Value Engineering

Final Report

Intake Diversion Dam Fish Protection and Passage Concept Design, Lower Yellowstone Project

July 29, 2002

Figure 8. Obermeyer Weir Photos

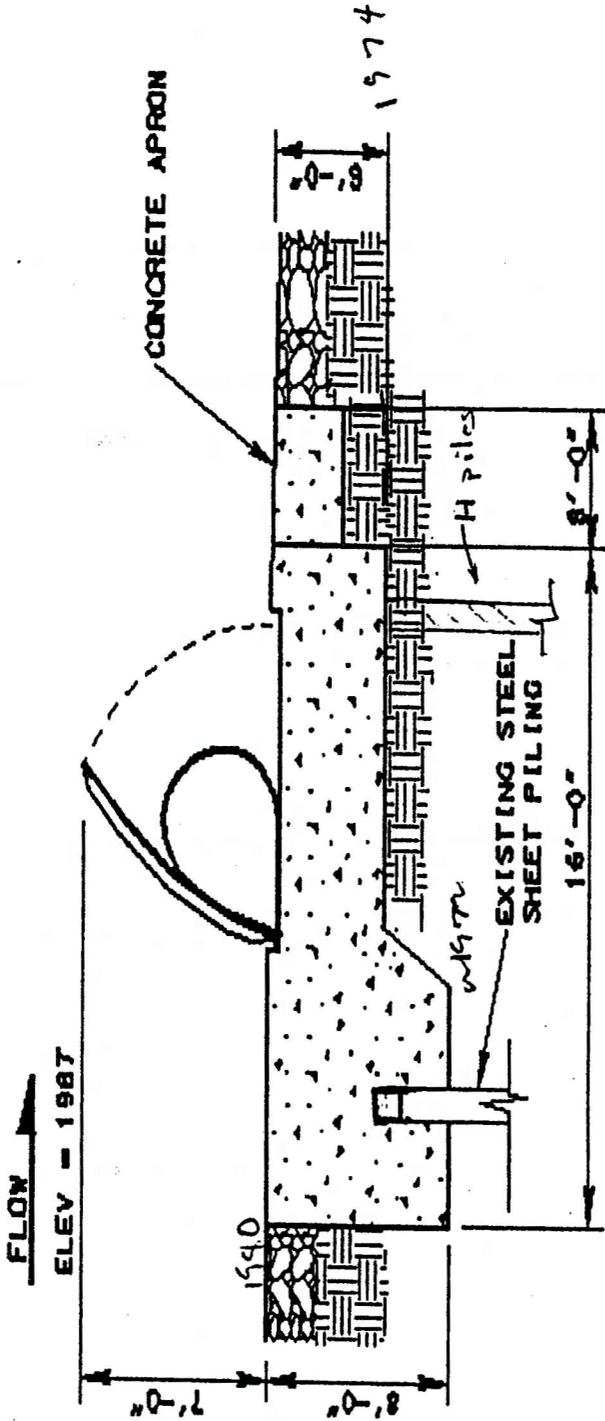
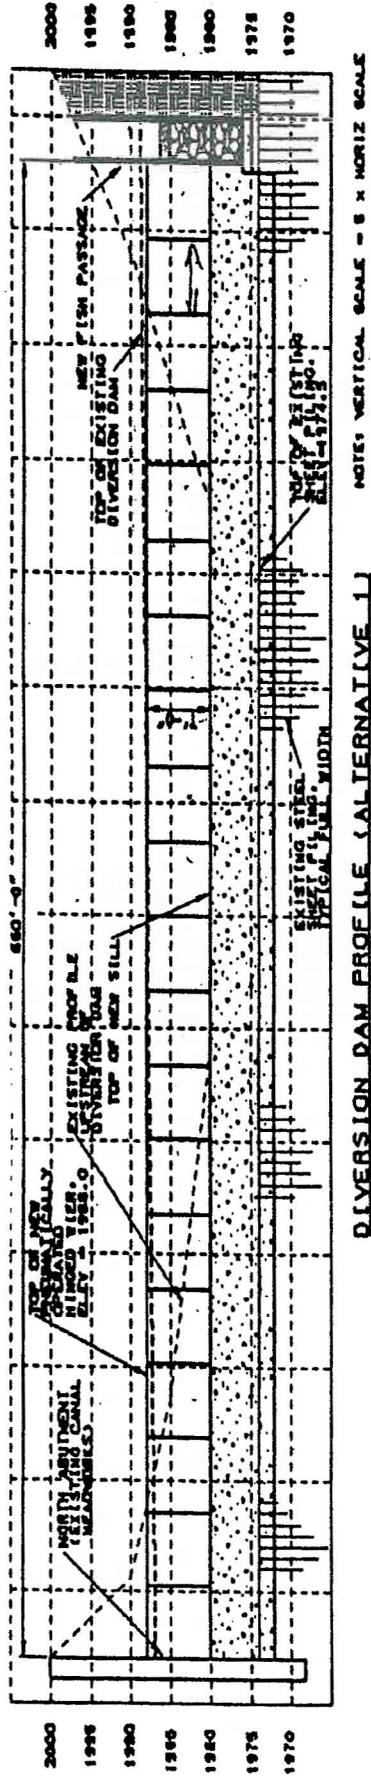
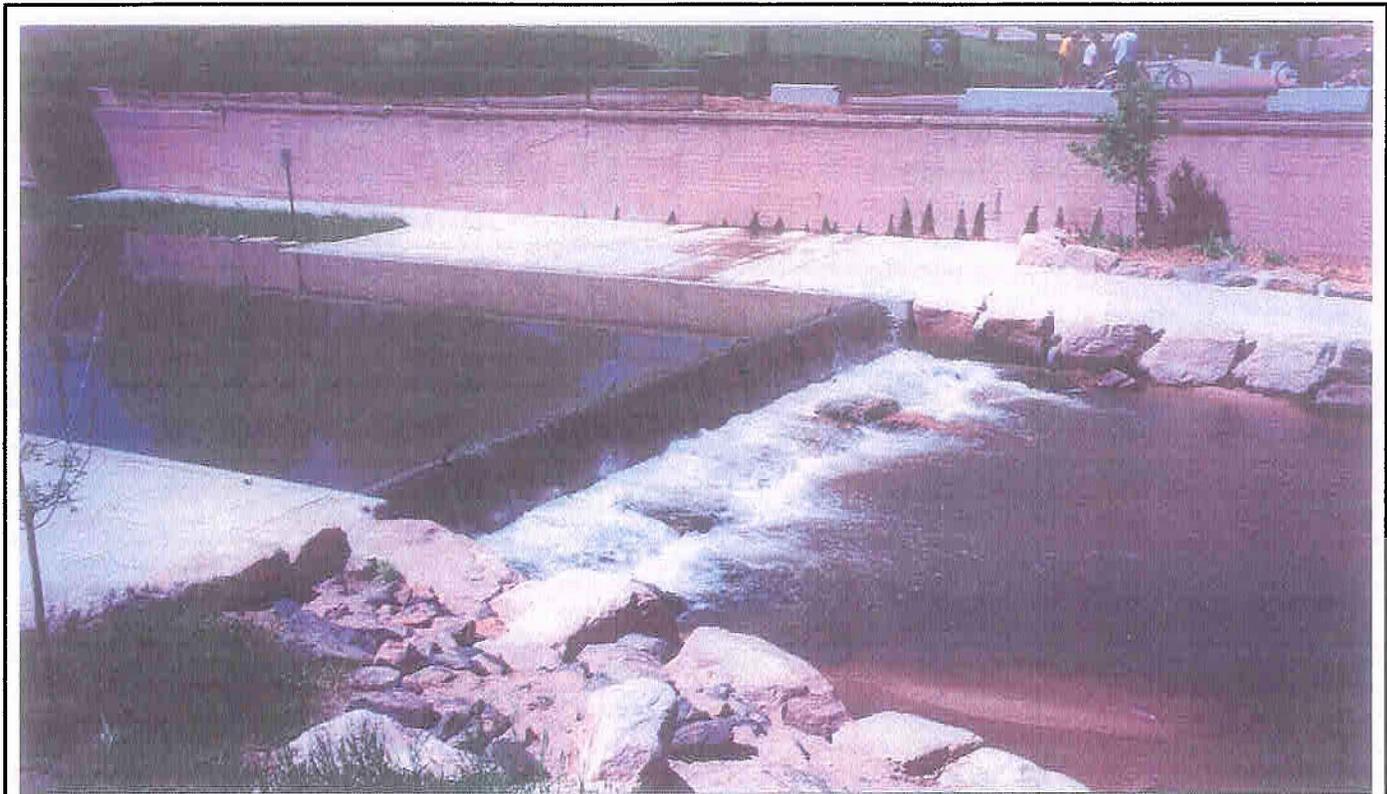
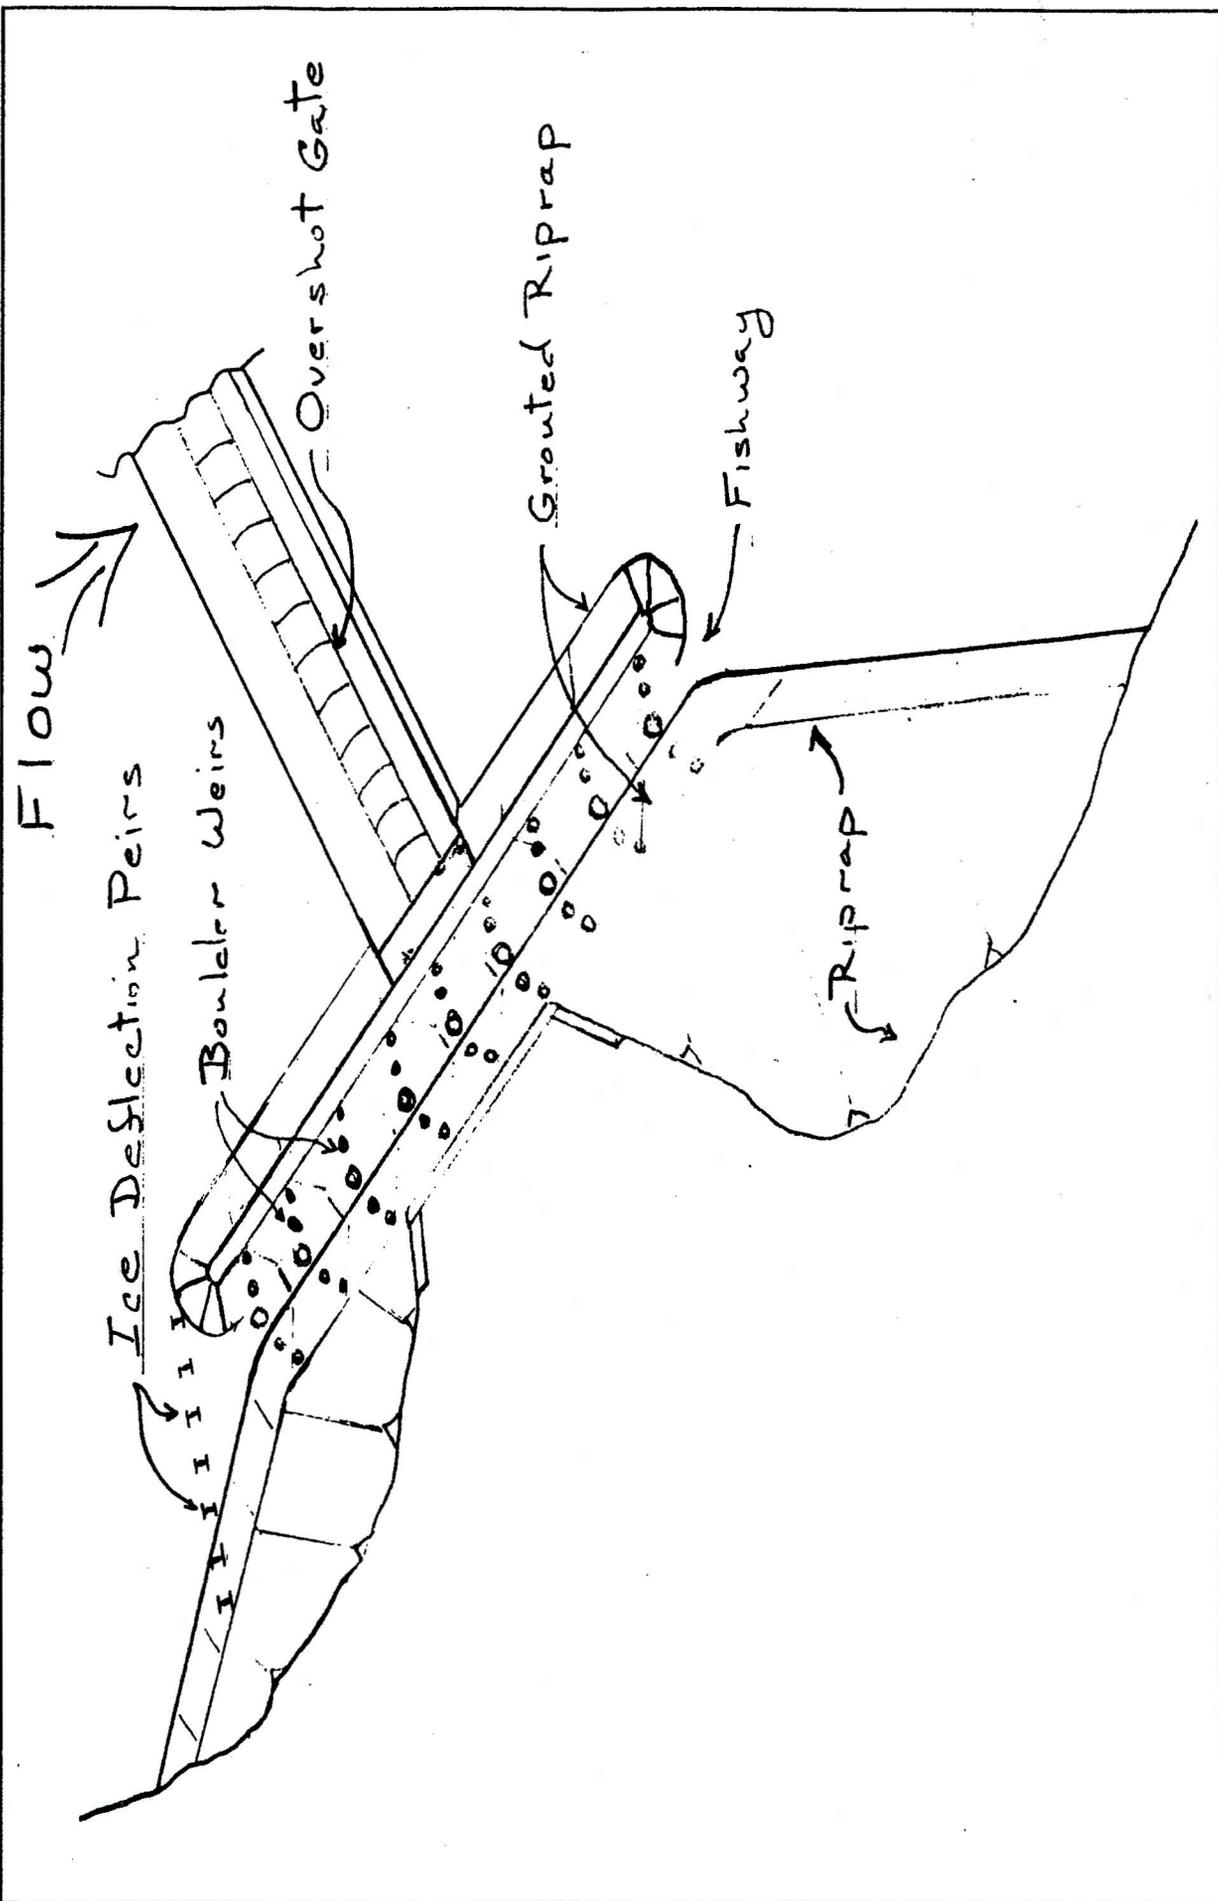
Proposal No. 1. Replace the Dam with a Collapsible Gate System and Fish Passage Channel.

- **Proposal Description:** Because the existing dam has exceeded its design life and requires annual addition of material to the crest to maintain integrity, consider replacing the structure at this opportunity. This proposal would remove the existing dam and replace it with hinged, collapsible gates (Obermeyer style) on a concrete foundation slab. An H piling/bearing should be incorporated to the front and back of foundation slab for added stability. The gates will span about 660 feet across the crest of the dam and will consist of 20 gates that are 33 feet wide. A fish passage channel would be located at or near the south abutment to provide fish passage during low-flow conditions (drought). During high-flow conditions, most or all of the gates could be completely lowered presenting almost no obstruction to movement. As flows begin decreasing in the river, additional gates could be raised, creating sufficient head for diversion of irrigation water. Existing data suggests that the rock that has been deposited on the dam crest through maintenance and has washed downstream has contributed to the impediment of passage of fish such as the pallid sturgeon. Rock that has washed out from the existing structure would be removed and incorporated into the project where applicable.

- **Changes from the Baseline Concept:** Removes and replaces existing dam with hinged weir and fish passage channel. This proposal is likely to increase opportunities of providing fish passage for a wider variety of native fish species over the baseline.

Figure 10. Screen Sill Section

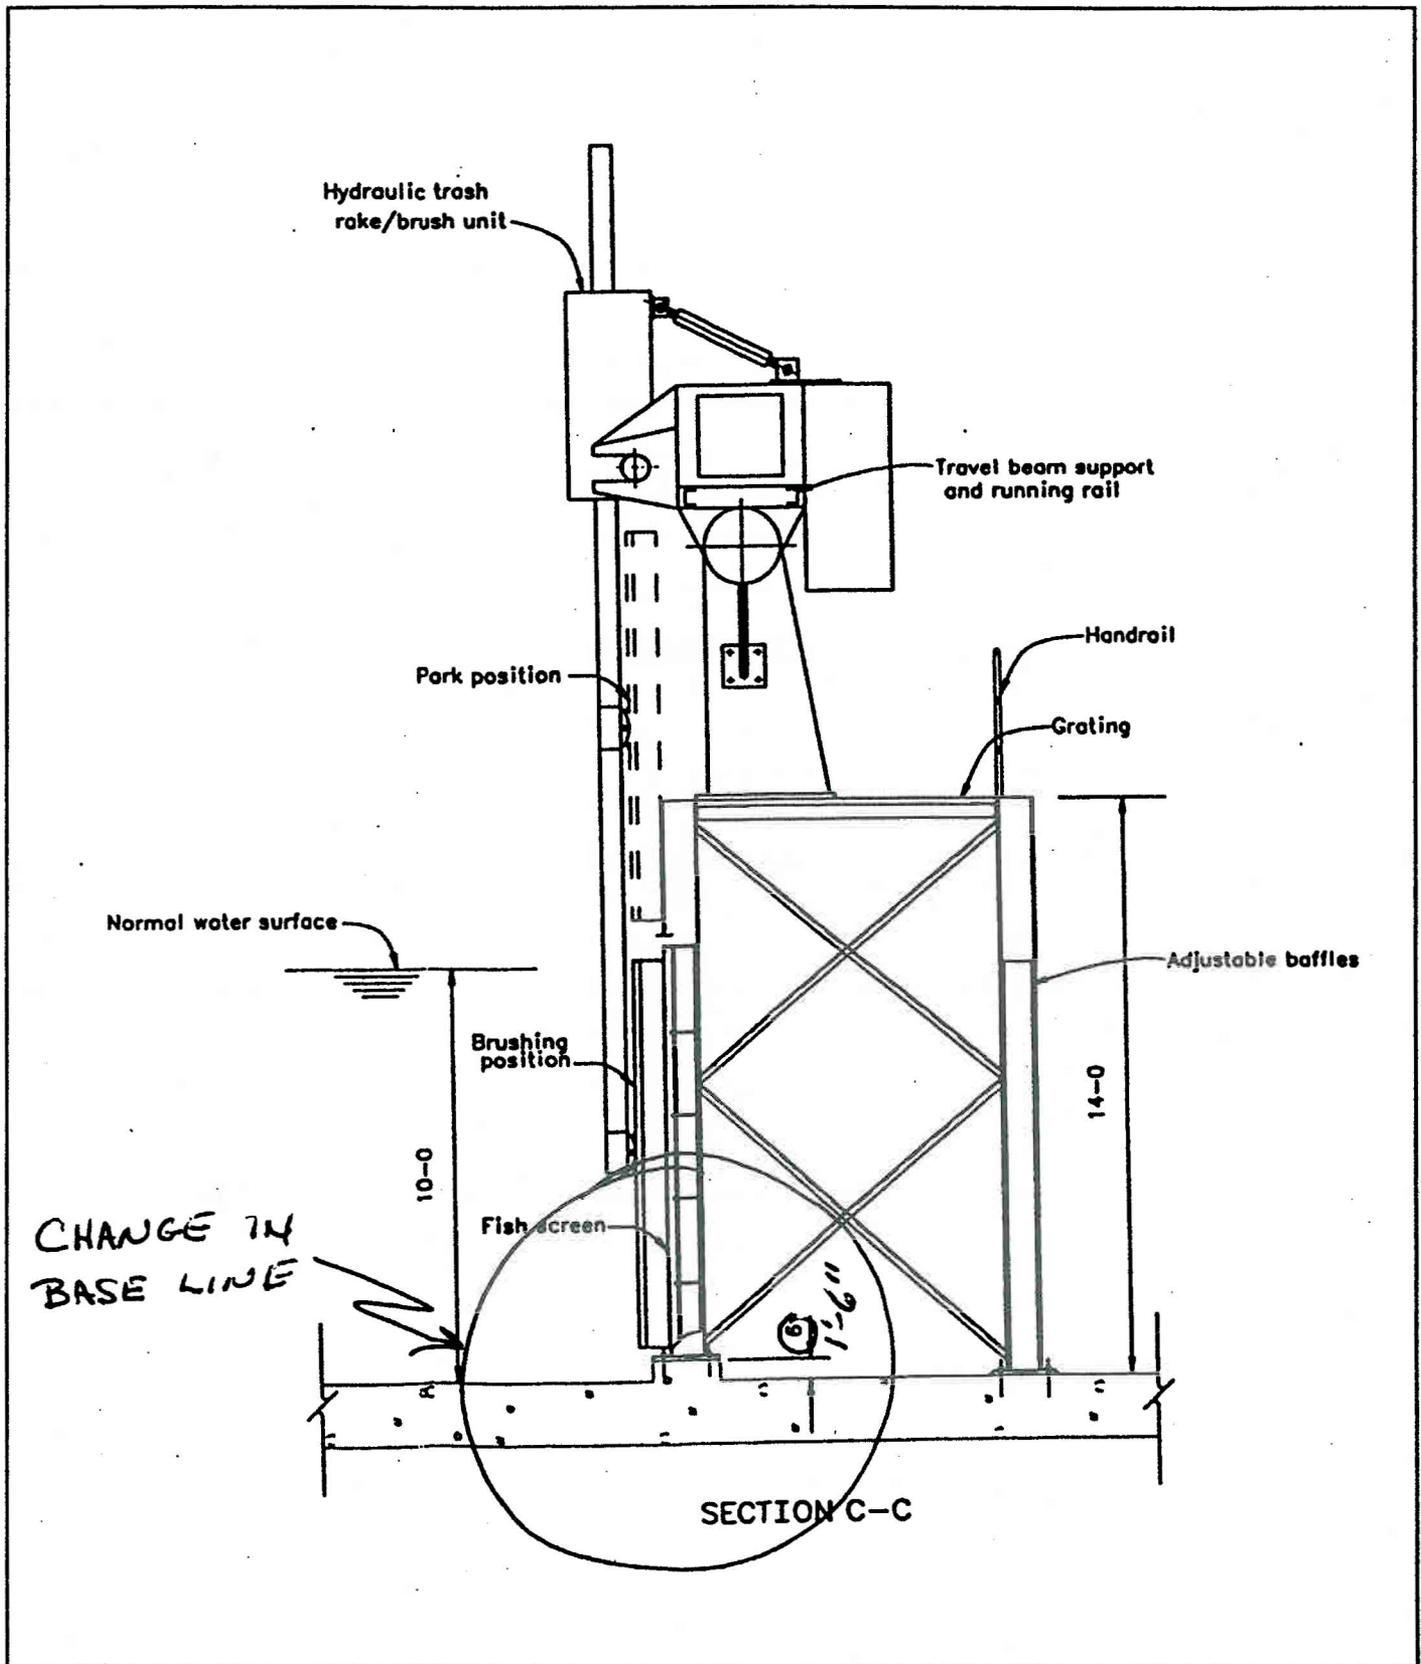
Proposal No. 2. Increase Height of the Concrete Sill under Screens to 18 Inches.

- Proposal Description: This proposal is to change the height of the concrete sill along the base of screen array from 6 inches to 18 inches, primarily to reduce exposure of bottom swimmers to the screens and to prevent silt buildup from impeding the screen cleaning brush. To keep the same wetted screen area, it will be necessary to substitute 37 - 9-foot by 9-foot screens in place of the 30 - 10-foot by 10-foot screens, lengthening the screen array by 33 feet.

- Changes from the Baseline Concept: Total screen length will increase from 300 to 333 feet. As a result, the constant width section length will increase from 350 to 380 feet. The angle of the screen array to the flow will decrease from 9.8 to 8.9 degrees.

Figure 11. Plan of Trap

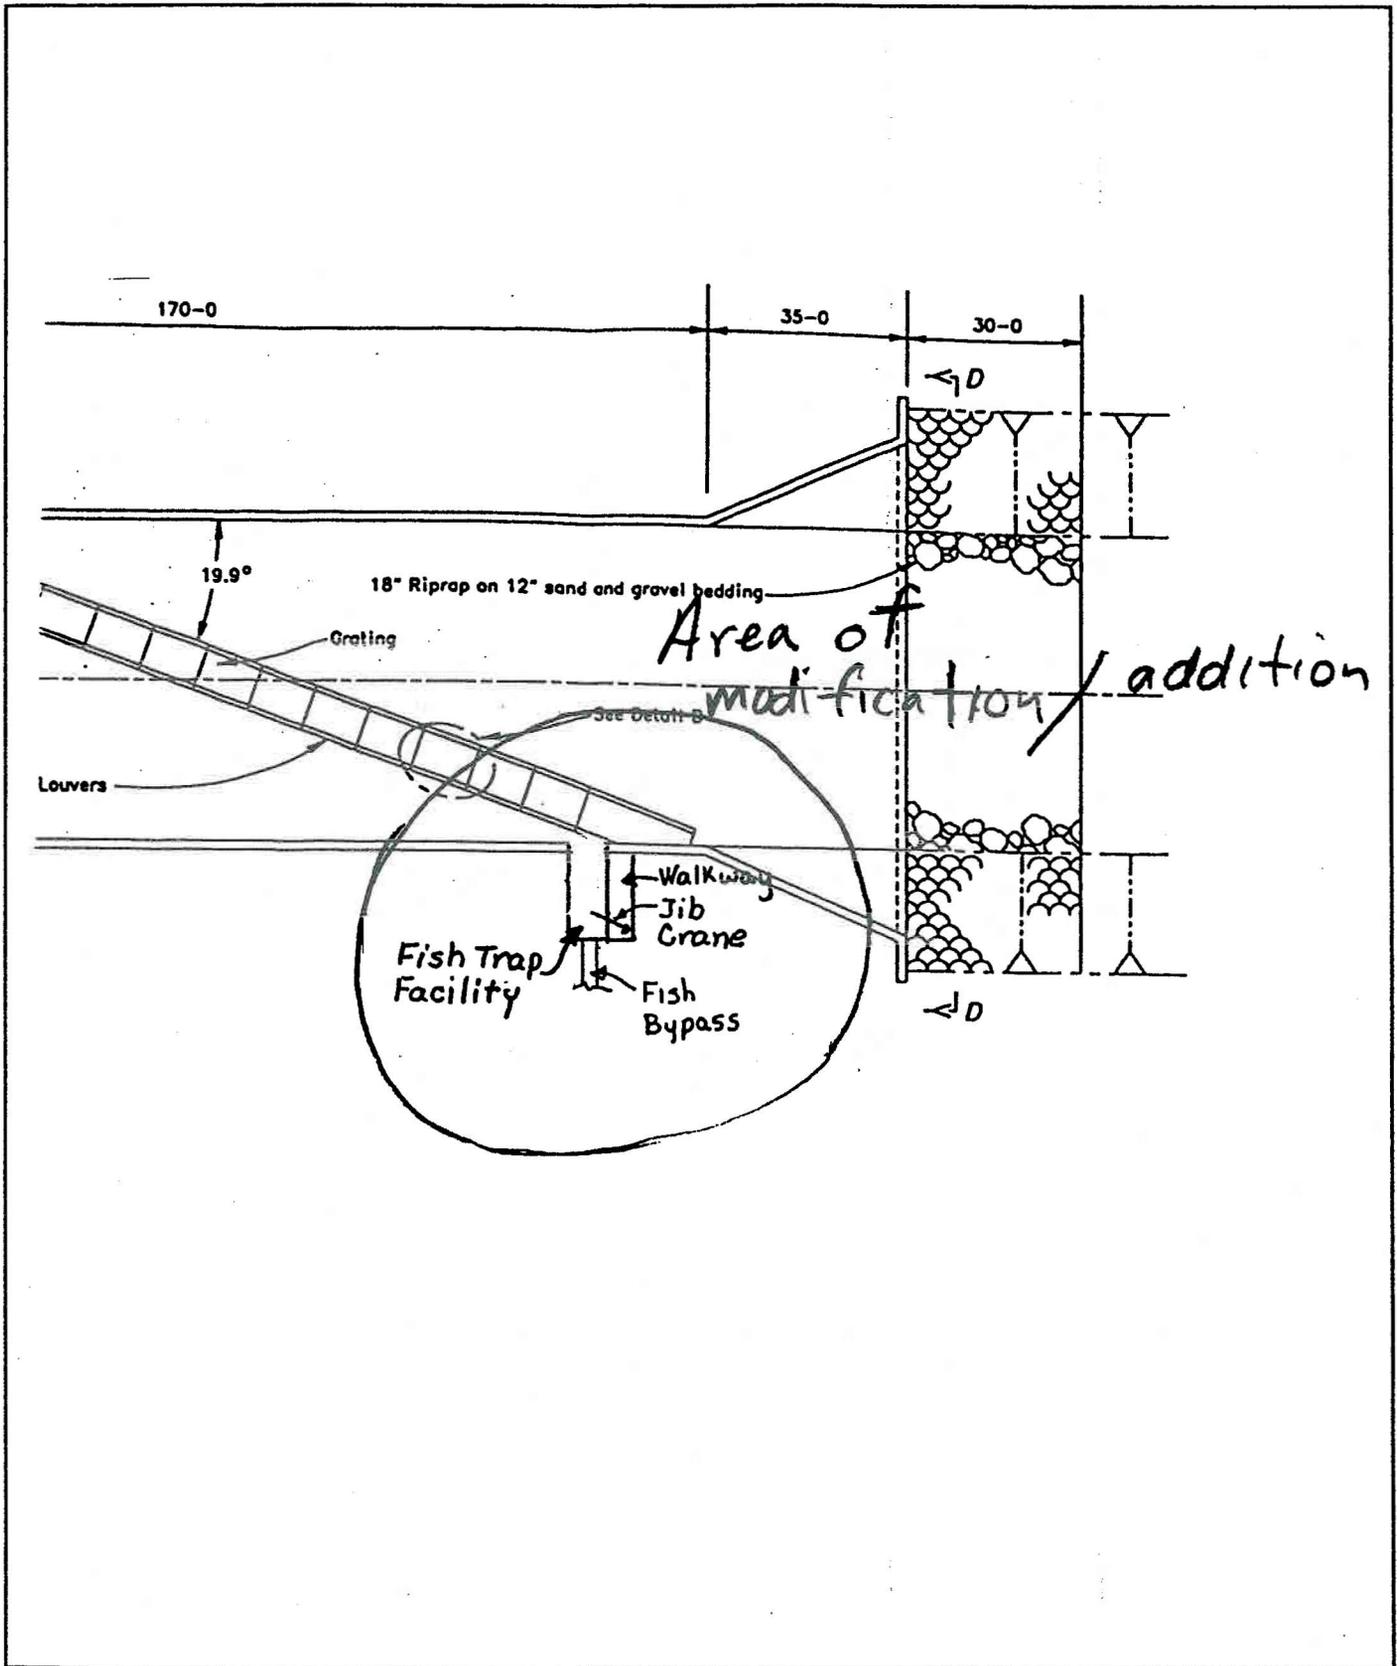
Proposal No. 3. Build a Fish Trapping Facility into the By-pass Area of Intake Canal Screen.

- **Proposal Description:** This proposal is to add a fish collection area and trapping device at the downstream end of the screen array, close to the entrance to the by-pass. The trap would be submerged in the by-passed flow for brief intervals to collect live fish for monitoring and research purposes.
